## SERVICE BULLETIN

Ride Manufacturer: Zamperla Inc.	Affected Production Dates: All
Ride Name: Mini Tea Cup	Affected Serial Nos.: All
Model Number: Mini Tea Cup

A hazard exists in the center cup spindle.

Cup center  
spindle

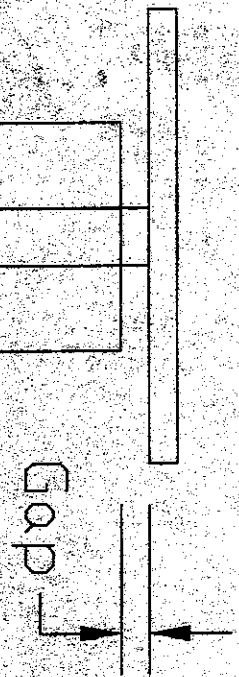
The steering wheel mounting pin is exposed and has the potential for snagging objects.

Raise the center spindle guard to close the gaps shown in the diagram.

Raise  
Clamp

Tighten  
Clamp
